From: Jenny Simpkins
Sent: Tuesday, July 30, 2024 3:52 PM
To: Clopper, Ben
Cc: Mike Helton; Tashakkor, Arash; Tad Leithead (tad@leitheadconsulting.com); Thomas, China; Lewis.Cooksey@gwinnettcountry.com; Mitchell, Winston
Subject: RE: GDOT PI 0016519 - SR 8 @ Jackson Creek - Updated Bridge Typical section
Attachments: pg8_9.pdf; pg4_5.pdf

From: Clopper, Ben <Ben.Clopper@mbakerintl.com>
Sent: Tuesday, July 30, 2024 9:01 AM
To: Jenny Simpkins <JSimpkins@cityoflilburn.com>
Cc: Mike Helton <mhelton@cityoflilburn.com>; Tashakkor, Arash <Arash.Tashakkor@mbakerintl.com>
Subject: GDOT PI 0016519 - SR 8 @ Jackson Creek - Updated Bridge Typical section

The City of Lilburn is collaborating with the Office of Program Delivery to upgrade the replacement of the bridge on Lawrenceville Highway over Jackson Creek (PI 0016519). We appreciate the department's commitment to incorporating feedback from municipalities and the public in your final design for these critical capital projects.

SR 8
TYP. SECTION #1
SUPERELEVATED SECTION

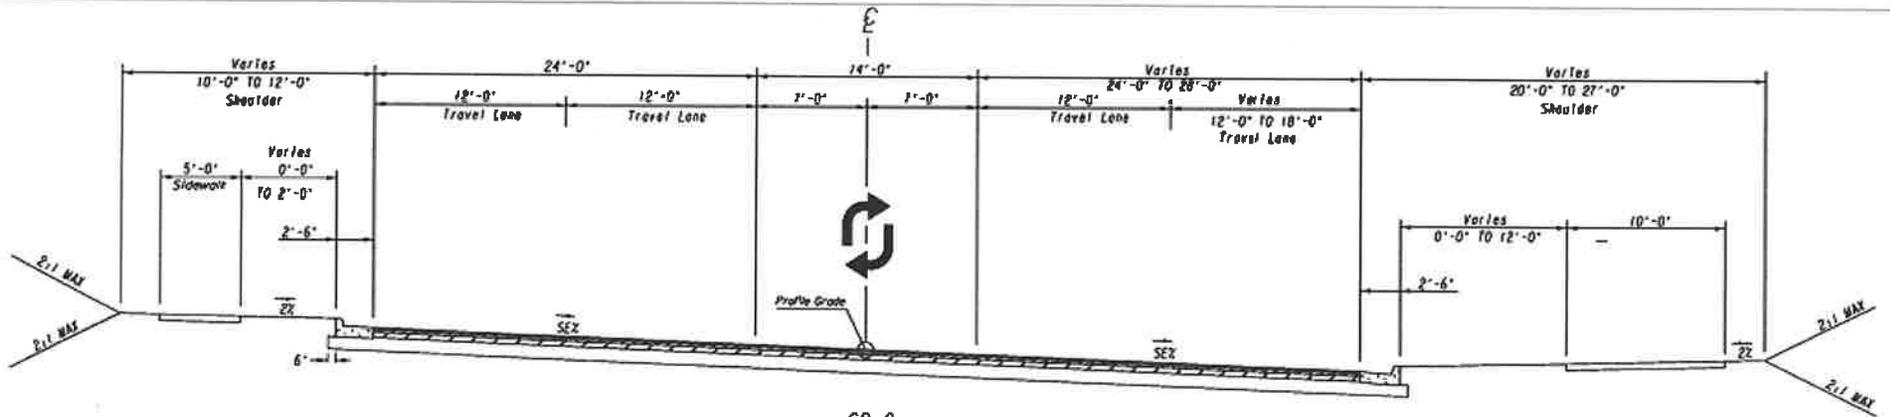
It was great to meet you all! We are working on the letter from Mayor Crist to GDOT requesting narrower travel lanes (reduce from 12 ft to 11 ft), a wider multi-use path (increase from 10 ft to 12 ft) separated from the travel lanes with a decorative wall/columns, no bicycle lanes, and a wider sidewalk (increase from 5 ft to 8 -10 ft). We look forward to getting a work order from you all to create our design standards for bridges on Lawrenceville Highway. Mike will send standards we've used on streetlights in the past, though this is open for additional dialogue. Attached are renderings of our conceptual ideas for Lawrenceville Highway. Please note that these concepts have not been vetted by the Mayor and Council, Gwinnett DOT, or GDOT. However, the concept is a target for the bridge design.

SR 8
TYP. SECTION #2
BRIDGE

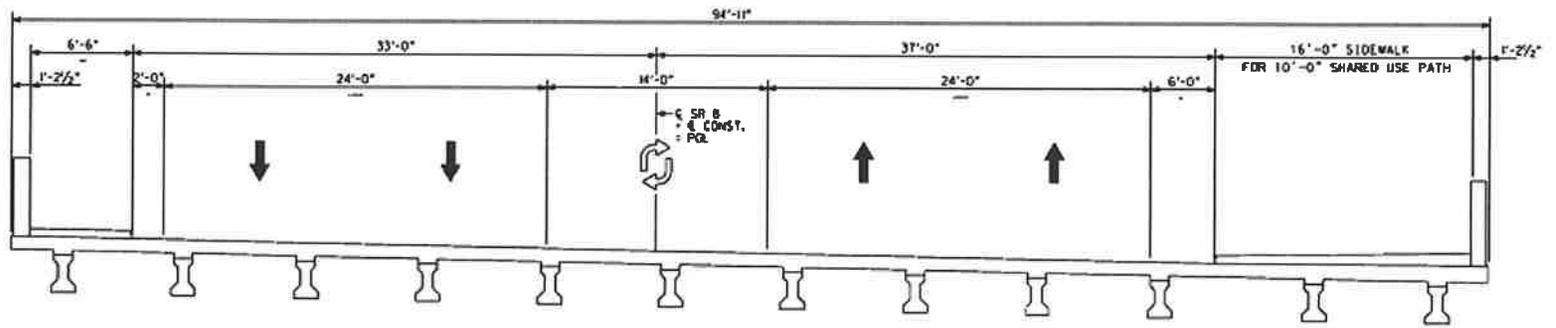
- add/change
- lighting
 - 12' multi-use path
 - Reduce lane widths to 11 ft
